Model
FX506LT
FX706LT

CHANGE LIST

Quanta Computer Inc.
PROJECT : FX506L/FX706L

Size	Document Number	CML 1/7 (JTAG/MISC)	Rev	2A
Date	Tuesday, March 24, 2020	Sheet	3	of 89

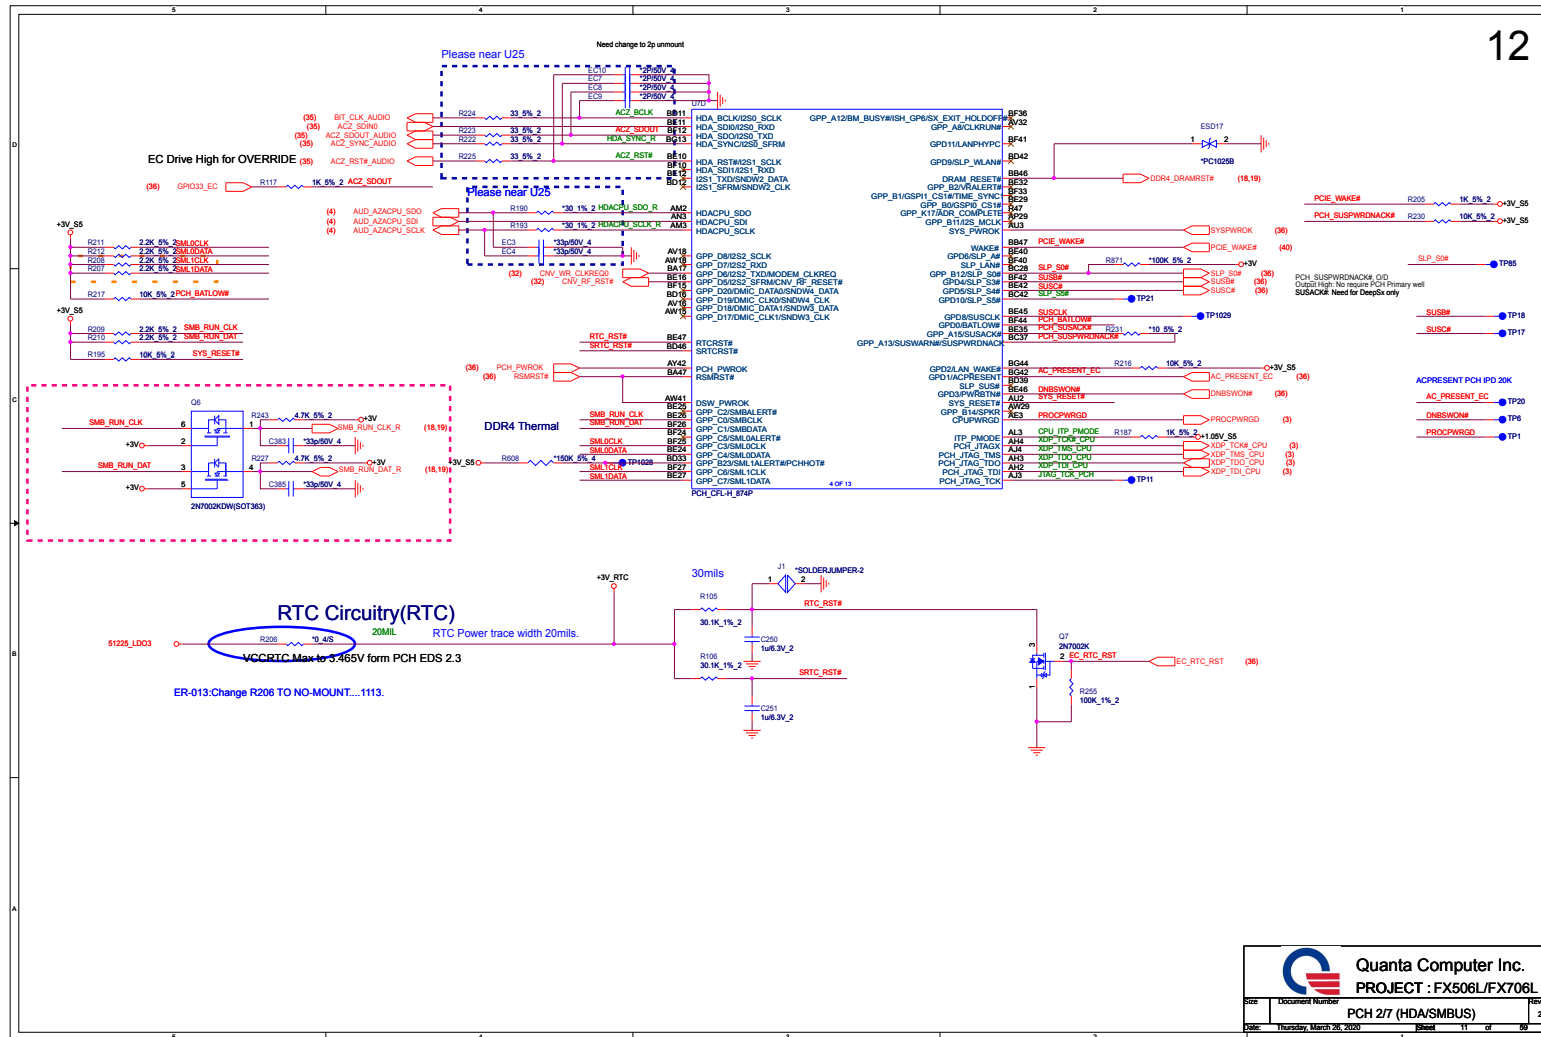
ER-027: Change R43 to no-mount and add R874 100K to GND for fixed GPU timing issue....1122.

USB 2.0 PORT1

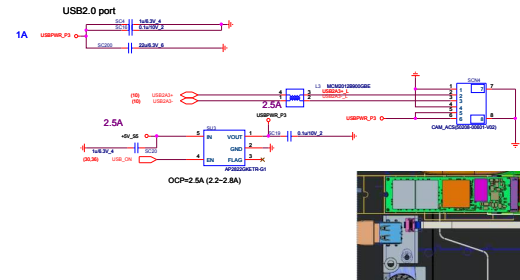
PR-E02:Remove CON6 for USB board FFC CONN.....0217

USB 3.2 GEN1 Type A/PORT2

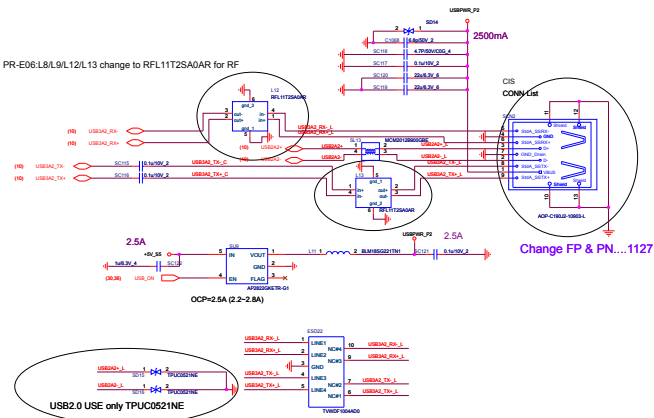
PR-E06:L8/L9/L12/L13 change to RFL11T2SA0AR for RF
